ADDENDUM NO. 002

RE: Water System Capital Improvements – Phase II
For Town of Bluefield
T&L Project No. 16176

DATE: June 8, 2023

DEVICE SCHEDULE - FALLS MILL VAULT:

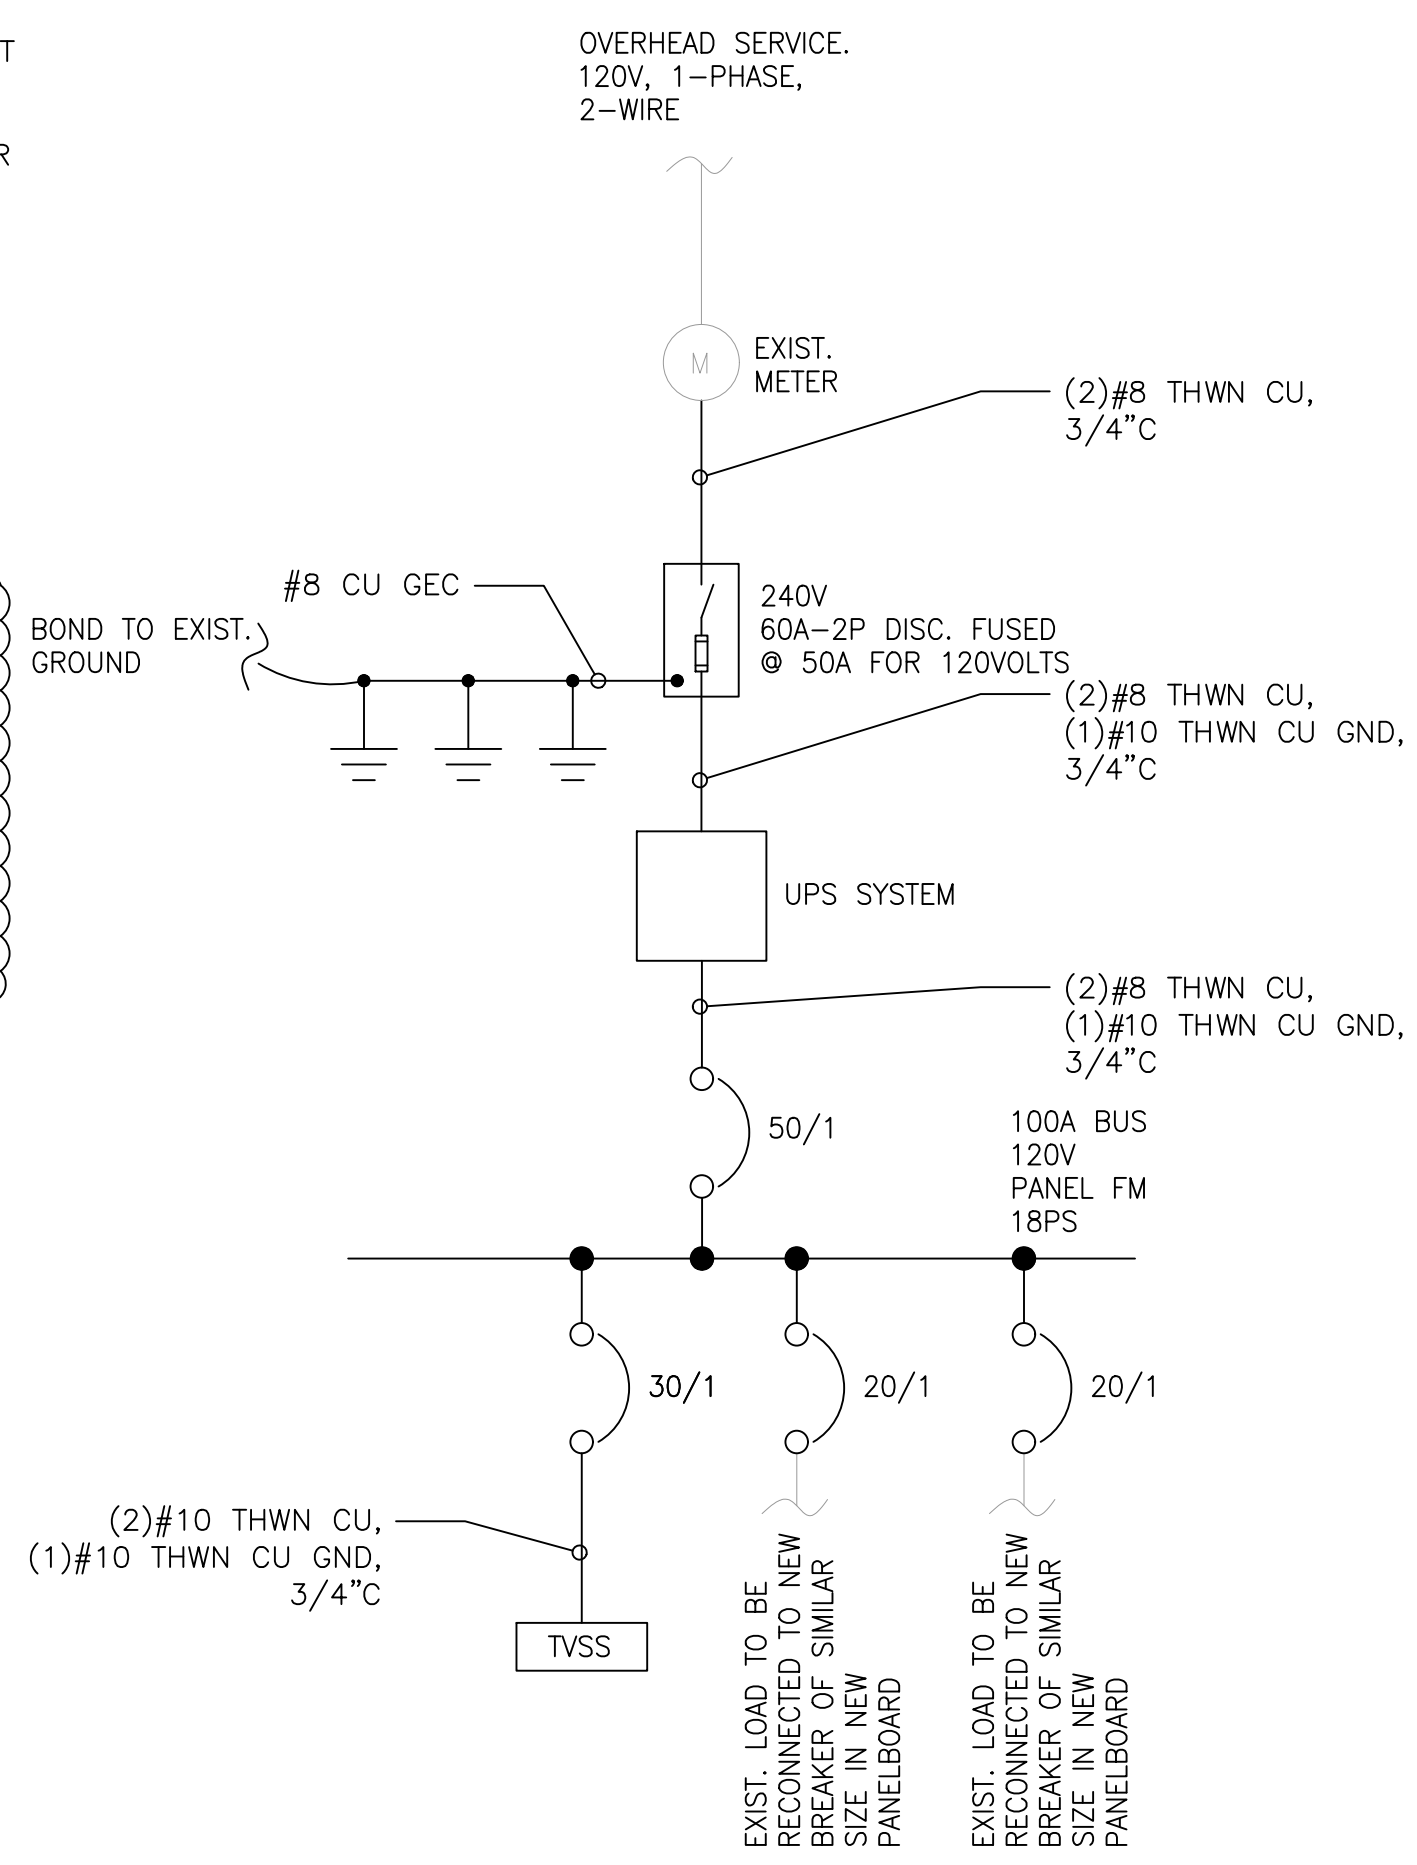
1. All new camera systems shall be on separate networks from the main station controls.
2. The 0.8PF stated on Risers E102 and E103 applies to both single or three-phase power.
3. The remote is to provide access on the exterior of the generator enclosure such that fuel is not spilled inside of the generator enclosure. Fuel fill shall be lockable.
4. Pipe material for lines between the basin and outfall shall be ductile iron as specified in Specification Section 33 1116 – Water Utility Distribution and Treatment Piping and Valves.

1. Drawing C103 has been revised to add new 12' wide double swing gates to the existing fencing between the park and the water treatment plan and add hatching to delineate the area adjacent to the basins where additional earthwork shall be performed to satisfy flood mitigation requirements. The revised drawing is enclosed.
2. Drawing C201 has been revised to add clarification for the ornamental aluminum fencing. The revised drawing is enclosed.
3. Drawing C207 has been revised to clarify the motor requirements for the Raw Water Pump. The revised drawing is enclosed.
4. Drawing E101 has been revised to shift text for visibility. The revised drawing is enclosed.
5. Drawings E102 and E103:
 - a. Additional information has been provided in regards to startup requirements.
 - b. Each ATS withstand requirement value based off of given fault current has been corrected.

- EXISTING GROUND ELECTRODE CONDUCTOR MAY BE REUSED IF CONDUCTOR CAN BE TRANSFERRED WITHOUT SPLICING AND IS SIZED AS INDICATED.
 - THE MAXIMUM AVAILABLE FAULT CURRENT FOR DOUBLE GATES TANK IS 1088A. ALL INSTALLED EQUIPMENT MUST MEET OR EXCEED THIS RATING. PROVIDE LABEL FOR NEW SERVICE DISCONNECT IN ACCORDANCE WITH THE NEC 110.24 'AVAILABLE FAULT CURRENT 1088AMPS, 02/21/2023.'

- THE MAXIMUM AVAILABLE FAULT CURRENT FOR FALLS MILL IS 1493A. ALL INSTALLED EQUIPMENT MUST MEET OR EXCEED THIS RATING. PROVIDE LABEL FOR NEW SERVICE DISCONNECT IN ACCORDANCE WITH THE NEC 110.24 'AVAILABLE FAULT CURRENT 1493AMPS, 02/21/2023.'
